HISTORIC AND DESIGN REVIEW COMMISSION

October 19, 2022

HDRC CASE NO: 2022-510
COMMON NAME: E Market at Hemisfair Park
LEGAL DESCRIPTION: NCB 13814 (HEMISFAIR - NORTHWEST QUADRANT), BLOCK 3 LOT 20
ZONING: D, H, RIO-3, Public Property
CITY COUNCIL DIST.: 1
DISTRICT: Hemisfair Historic District
APPLICANT: FitzGerald Associates Architects, PLLC
OWNER: PH Hemisfair LLC
TYPE OF WORK: Construction of a mixed-use tower, construction of a retail structure
APPLICATION RECEIVED: September 30, 2022
60-DAY REVIEW: Not applicable due to City Council Emergency Orders
CASE MANAGER: Edward Hall

1. Construct a 3-story retail structure to feature 2 stories above street level and 1 level at river level.
2. Construct a 29-story structure to feature residential and retail space. The proposed new construction will feature 360 residential units and 7 levels of structured parking.

Architectural site plan of the BASEMENT & RIVER LEVEL. The plan shows a large parking area with 151 stalls, a retail area (10338 SF), and various utility rooms. Key features include:

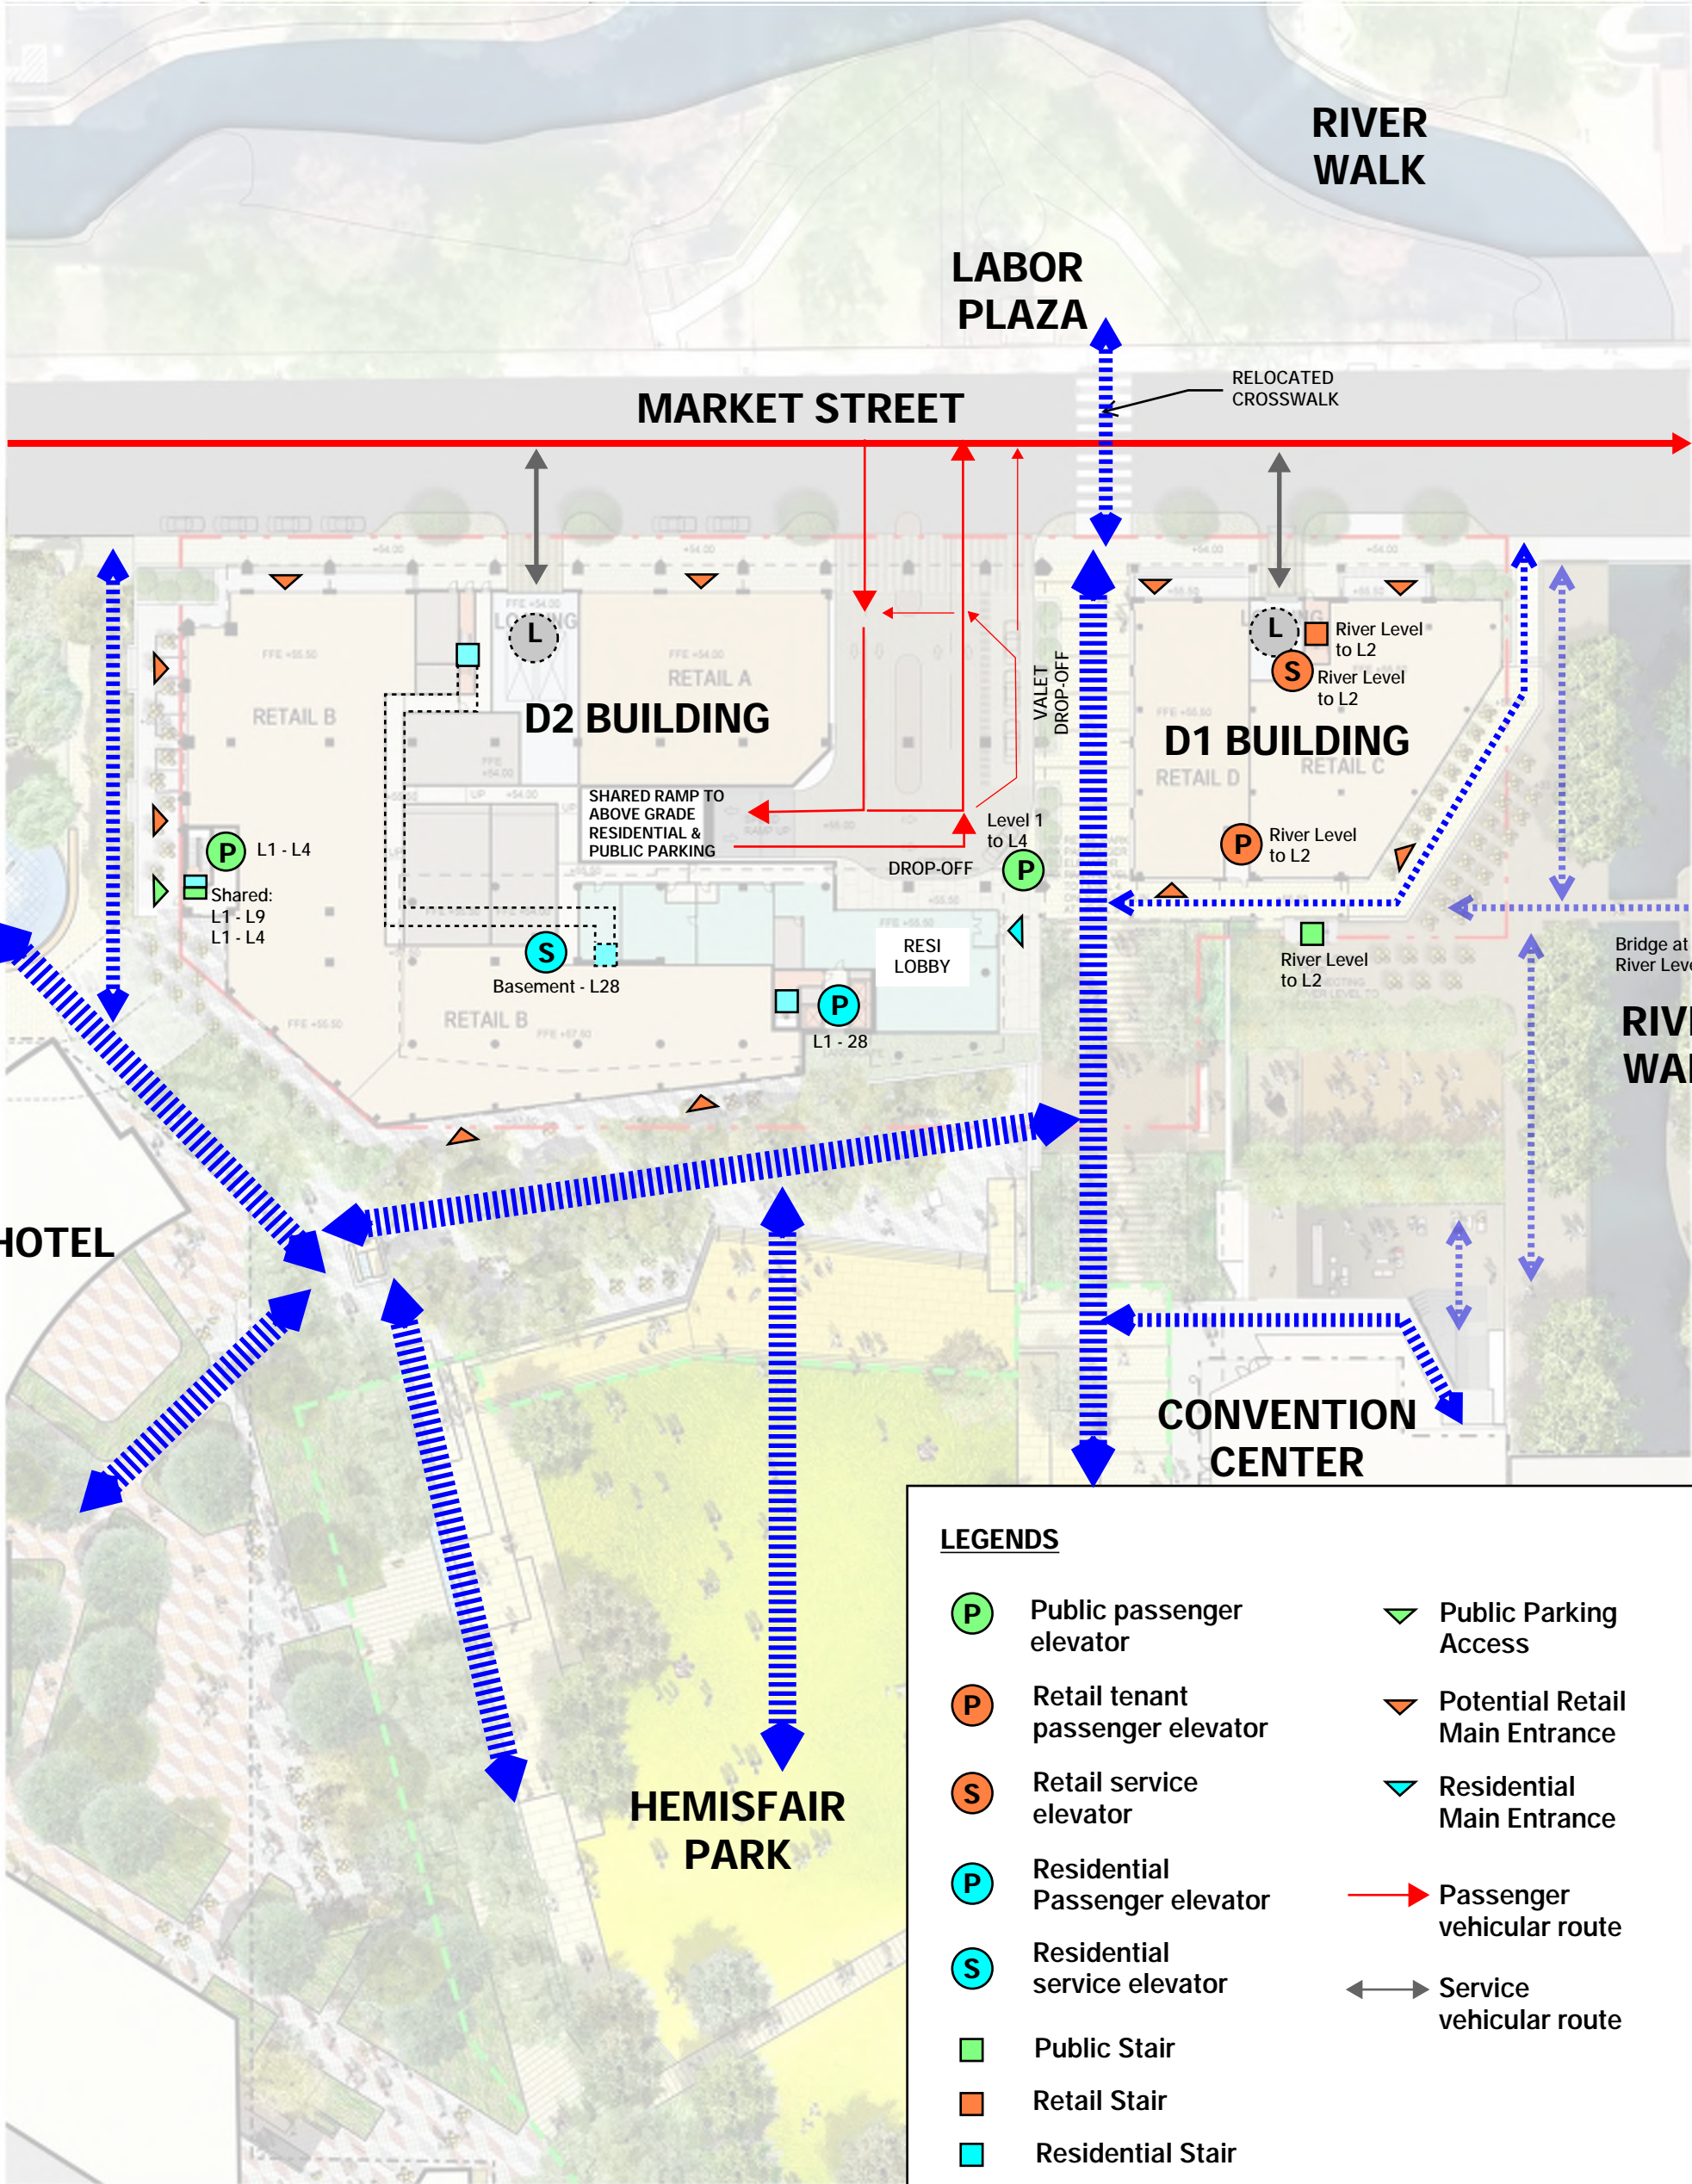
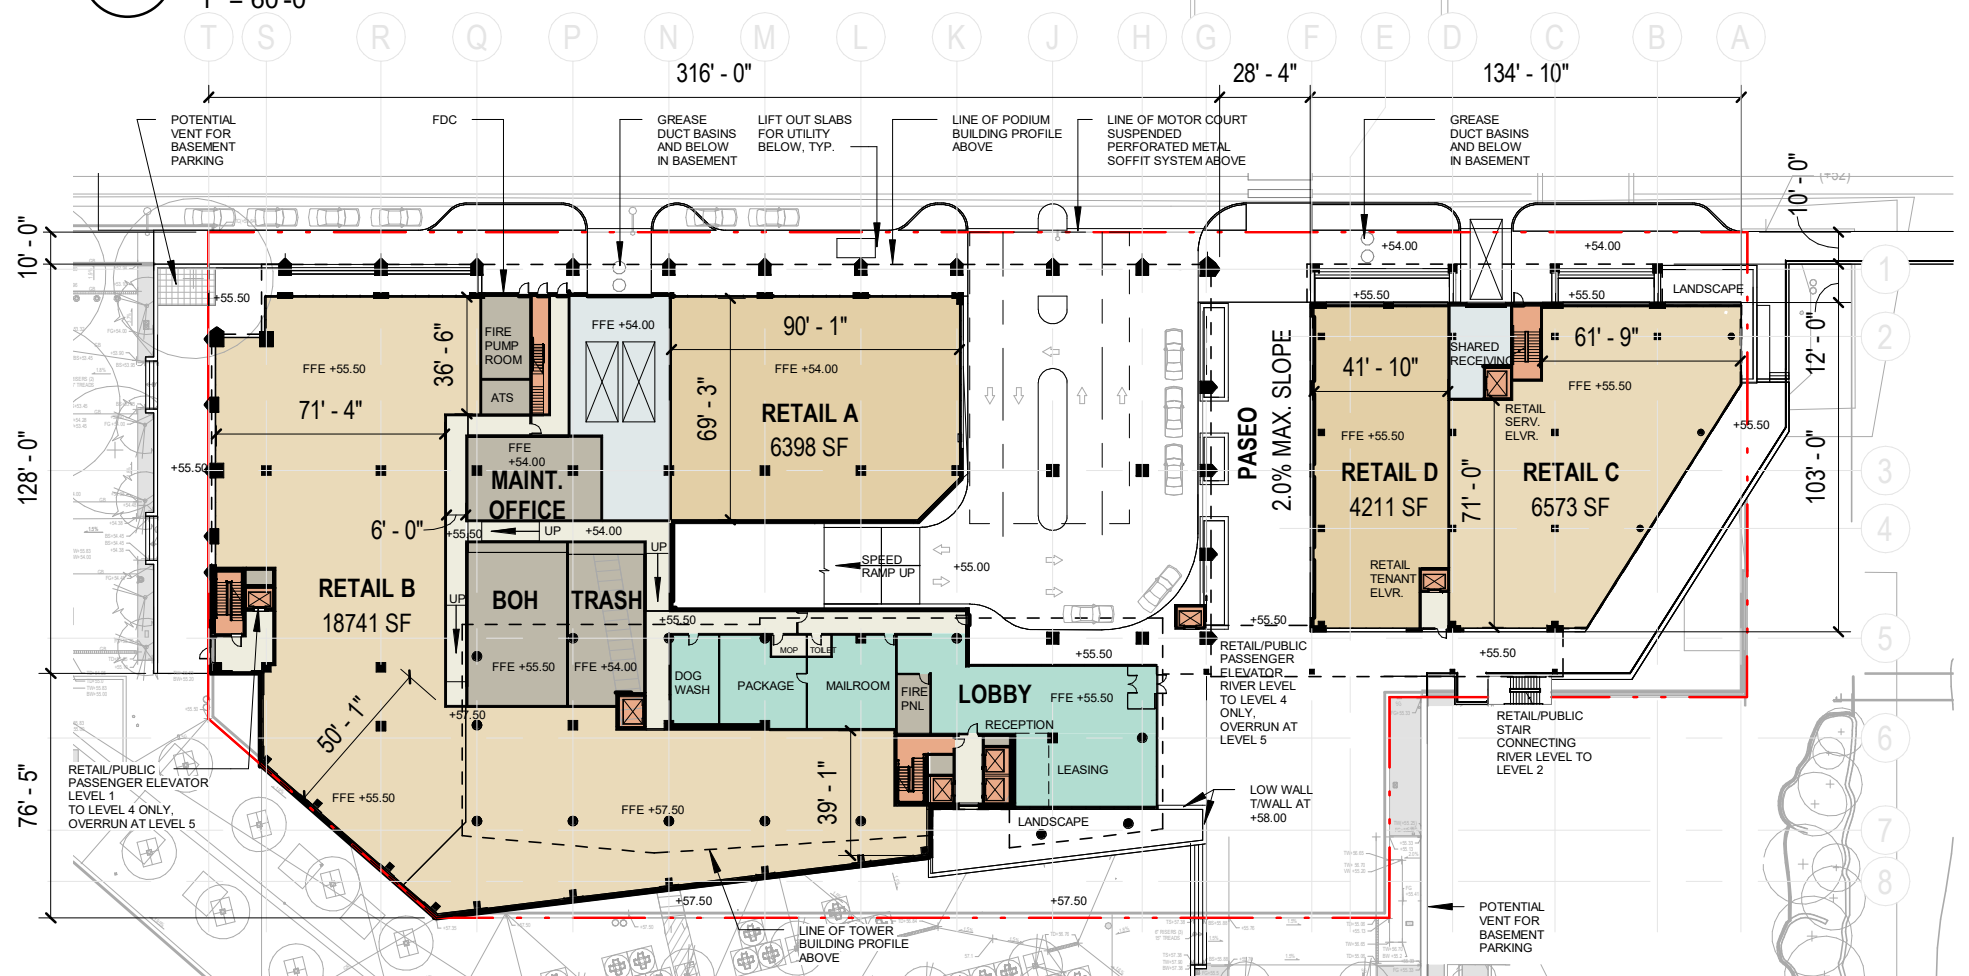
- e. CURB CUTS – There are currently three (3) on E Market at this site. The applicant has noted three curb cuts on the site plan. One curb cut is associated with loading at the 3-story retail structure. The other two curb cuts are associated with the 29-story tower. One curb cut will facilitate vehicular traffic to and from the structured parking while the other will be for loading. The UDC Section 35-672(b)(1)(A) notes that curb cuts should be limited to two on parking areas or structure facing only one street and one for each additional street face. Additionally, the UDC notes that curb cuts should not exceed more than twenty-five (25) feet in width. Generally, staff finds three curb cuts to be appropriate given the scale of the proposed new construction; however, staff finds that each curb cut should not exceed twenty-five (25) feet in width. Additionally, staff finds that each curb cut and approach should be installed in a manner that does not result in a grade change in the pedestrian path. Should a curb cut be proposed to exceed twenty-five (25) feet in width, staff finds that additional design elements should be incorporated to ensure safe pedestrian interactions such as the incorporation of an additional traffic median to the immediate left of the valet drop off within the building footprint and the landscaping of the proposed traffic medians.

MS: General satisfaction with updates. Questions about parking and retail A. MB: Retail A will open up to E Market, not to the side garage entrance. MS: Will loading at D1 take place inside of the building? MB: No; there will be a back in location. MS: More consideration should be paid to loading; a truck should not block the sidewalk at this location. MS: Concerns regarding the paseo and vehicular drop off (car exhaust).

JF: Questions about curb cuts; how will vehicular and pedestrian traffic interact adjacent to the site. Texture and color of paving will occur where pedestrian paths cross curb cuts.

- i. That additional design elements be incorporated to ensure safe pedestrian interactions such as the incorporation of an additional traffic median to the immediate left of the valet drop off within the building footprint as noted in finding e. Landscaping, planters, and special paving treatments should be introduced to enhance the pedestrian experience.
